Re: CPV Sentinel Energy Project: Docket No. 07-AFC-3

Subject: CPV Sentinel, LLC Energy Project (07-AFC-3)  
Mission Creek Ground Water Subbasin

# CPV SENTINEL – DRAFT CONDITIONS OF CERTIFICATION FOR THE SOIL AND WATER SECTION OF THE FINAL STAFF ASSESSMENT

**DESERT WATER AGENCY**  
 MISSION CREEK SUBBASIN  
 CPV SENTINEL ENERGY PROJECT  
 WATER RECHARGE QUANTITIES AND WATER WELL HYDROGRAPHS

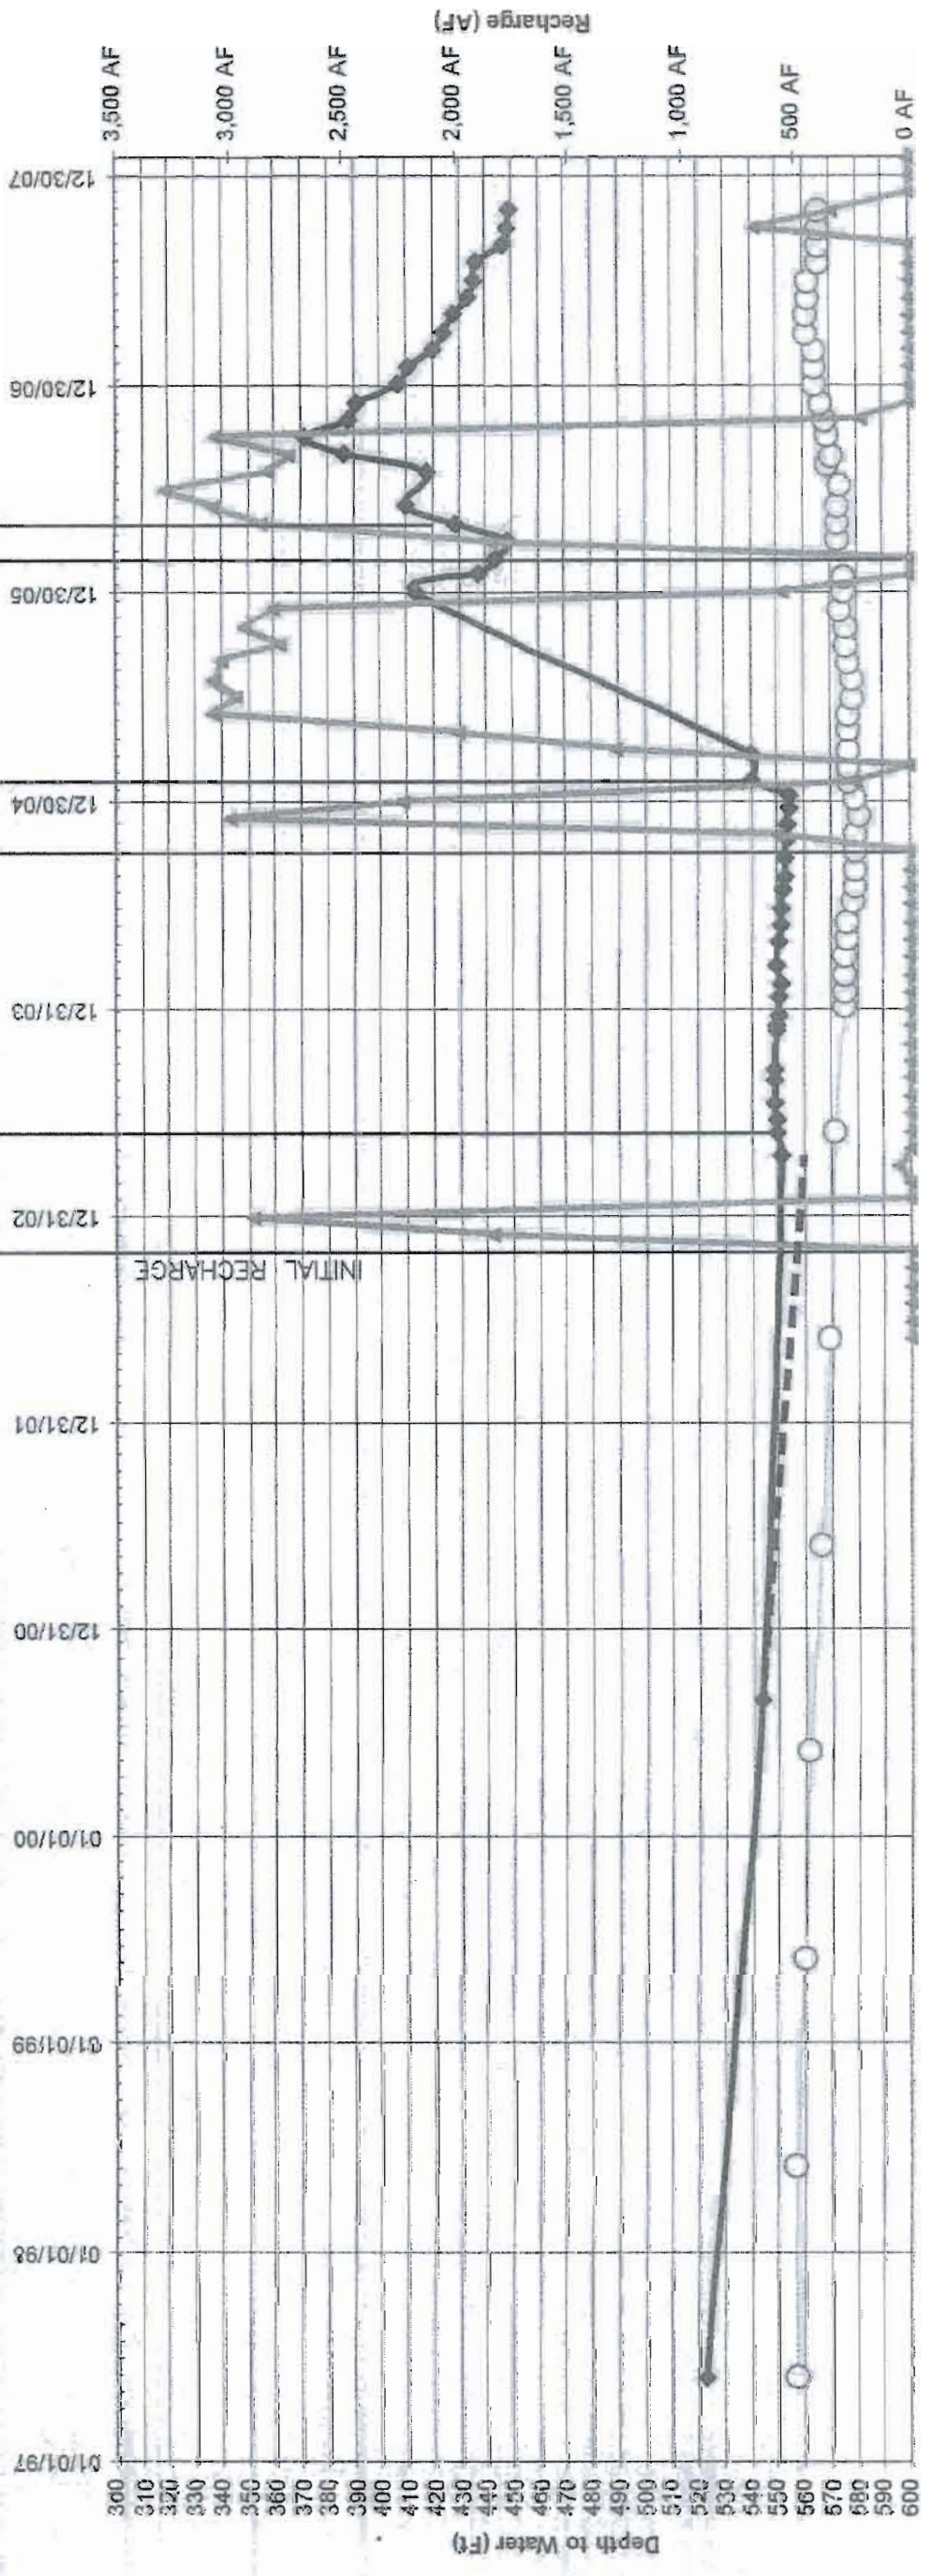
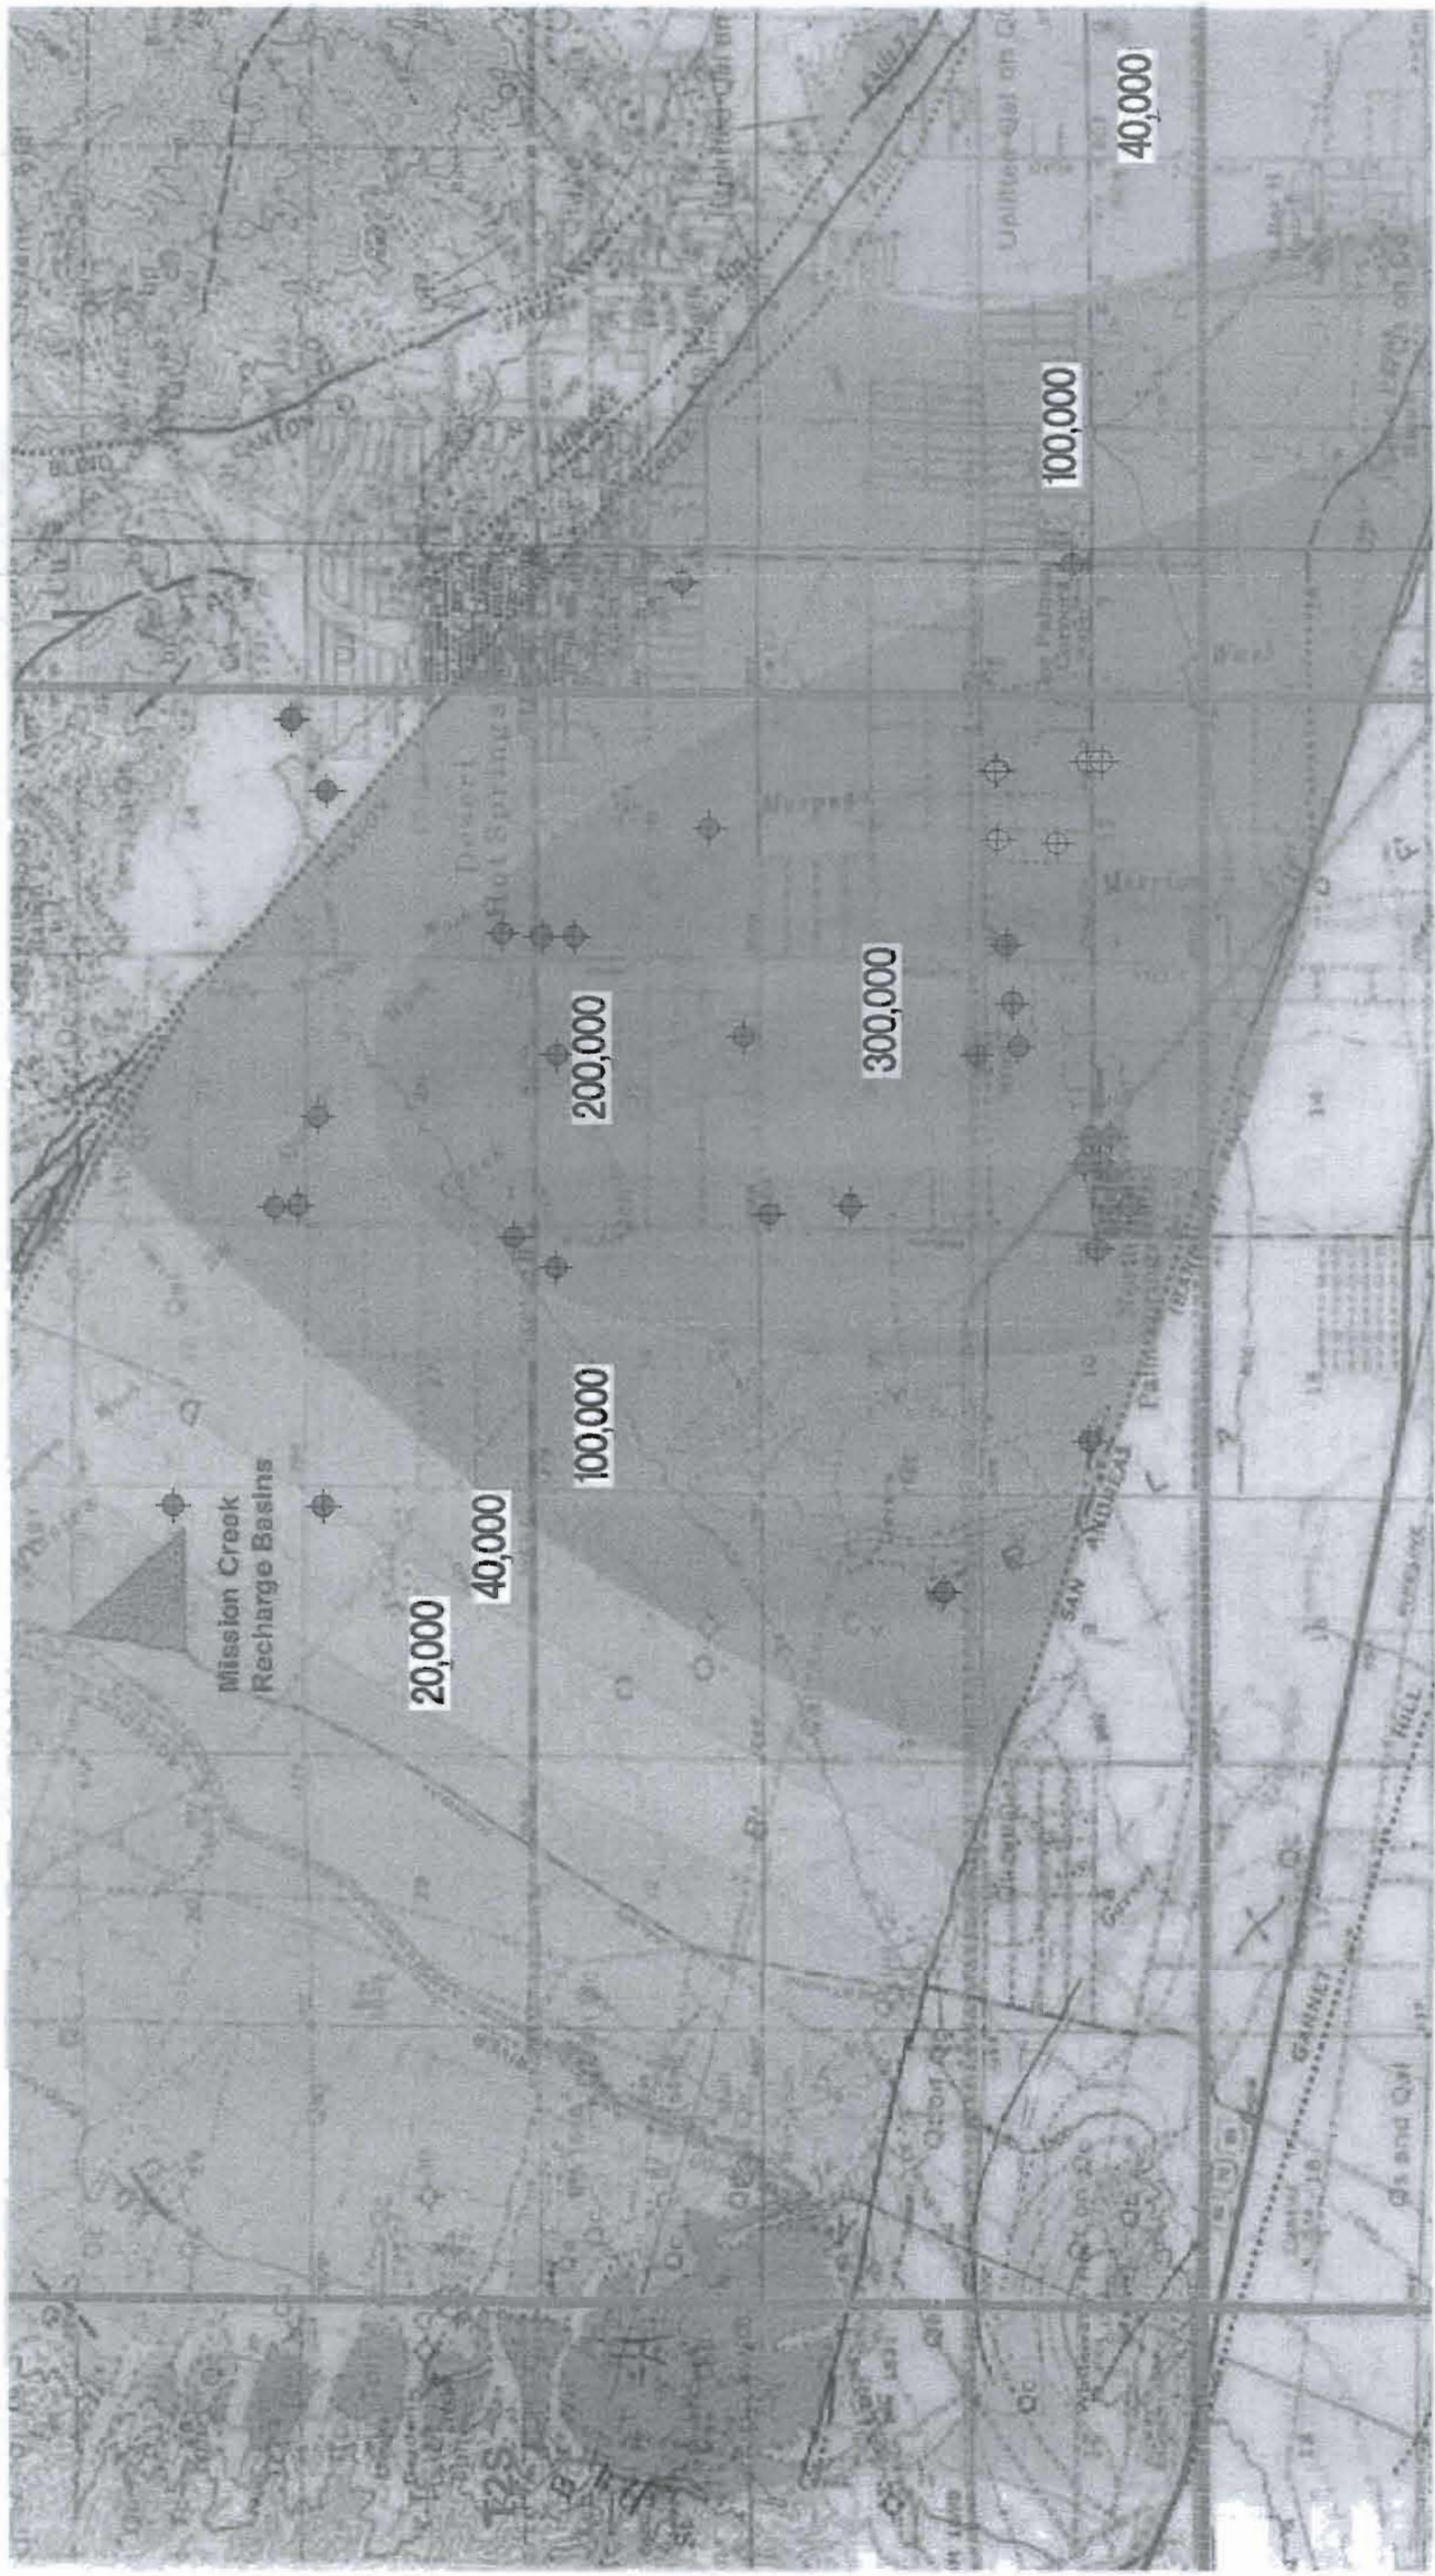
Figure 1, attached, shows water levels in the Mission Creek Monitoring Well (MCMW) located at the Mission Creek Recharge Basins and in Mission Springs Water District's (MSWD) Well 30, both as related to ground water recharge. Water levels are expressed in measured depth to the water table and recharge is based on Metropolitan Water District month-end water delivery meter readings.

The first indication of rising water level in the MCMW was on May 29, 2003 (about seven months after initiation of recharge activities), when the water level rose 1.5 feet (ft) from the previous measurement, which was made on April 18, 2003 (about six months after initiation of recharge activities).

Since no water level measurements were made during 2003 before April 18, 2003 or between April 18 and May 29, the water level may have begun to rise sooner. If the slope of the declining water level were projected in a linear fashion based on the two earliest water level measurements (May 27, 1997 and August 29, 2000, see dashed line on Figure 1), it is likely that water levels had begun to rise by the April 18, 2003 water level measurement and perhaps even sooner, specifically six months or less.
